CONTRACT CHANGE ORDER

CCO: 247 Suppl. No. 0 Contract No. 04 – 0120F4 Road SF-80-13.2/13.9 FED. AID LOC.:

ALTERNATE CABLE BAND DETAIL (FIELD ADJUSTMENTS)

SAN FRANCISCO OAKLAND BAY BRIDGE EAST SPAN SEISMIC SAFETY PROJECT	
SELF-ANCHORED SUSPENSION BRIDGE (SUPERSTRUCTURE & TOWER)	
CABLE BAND DETAILS NO. 3B	
CU 04 EA 0120F1	DISREGARD PRINTS BEARING EARLIER REVISION DATES
REVISION DATES (PRELIMINARY STAGE ONLY)	SHEET 34352 OF

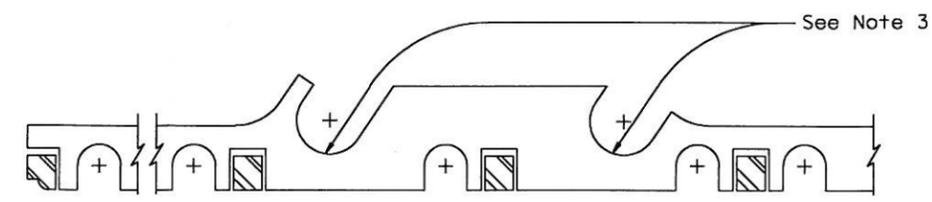
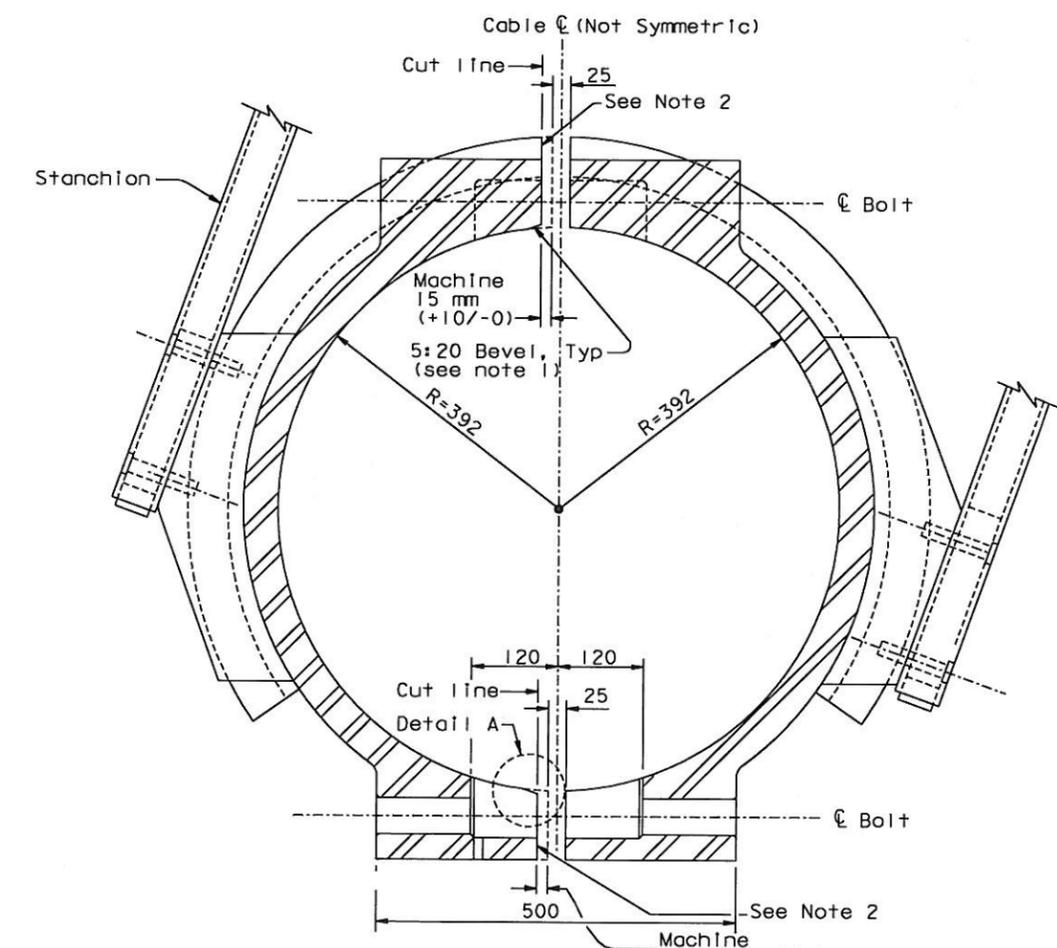
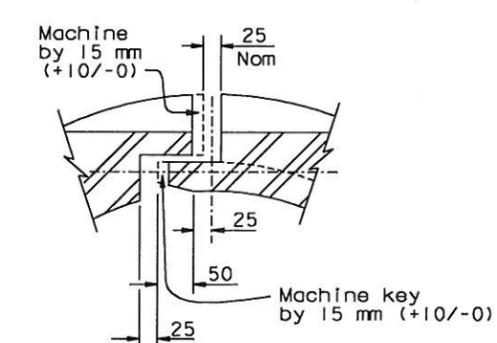
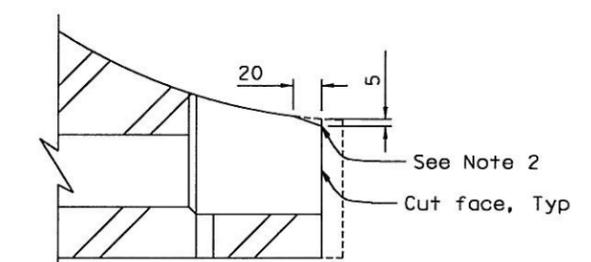
a. Bevel Cable Bands

Bevel the inside corner of the cut gap faces at 5 mm: 20 mm as depicted in ABF-RFI-001190R00 for all south cable bands.

Female Half:

- i. Machine 15 mm +10/-0 from the top and bottom faces of the cable band. Provide a 100 mm offset reference line prior to machining
- ii. Bevel the inside corner of the cut gap faces at 5 mm: 20 mm as depicted in ABF-RFI-001190R00
- iii. Dress the edge of each suspender groove with a 5 mm minimum radius
- iv. Dress all other sharp edges with a 2 mm minimum radius

Male Half:

- v. Trim the tip of all shear keys by 15 mm
- vi. Dress the edge of each suspender groove at a 5 mm minimum radius
- vii. Dress all other sharp edges with a 2 mm minimum radius

The following revised plan sheets detail the changes addressed in this change order: 760S2 (of 1204) as shown on sheet 3 of this change order.

1. Bevel inside corner of cut gap face by 5:20 top and bottom.
2. Dress all cut edges to 2 mm minimum radius.
3. Dress edge of suspender groove to 5 mm minimum radius.
4. For information not shown, see "Cable Band Details No.3" sheet.
